## TE Connectivity

Product Change Notification: PCN-24-228035

2P/3P LATCHED POKE-IN WTW CONNECTOR

2P/3P LATCHED POKE-IN WTW CONN

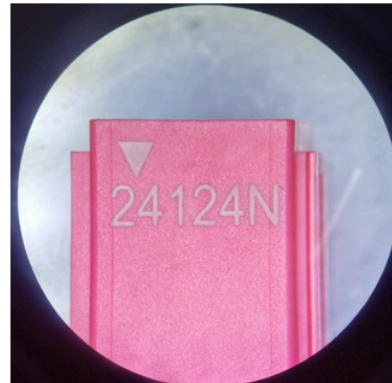
The date code & power lines marked with an Inkjet on the product is replaced with laser printing.

Inkjet print

Laser print
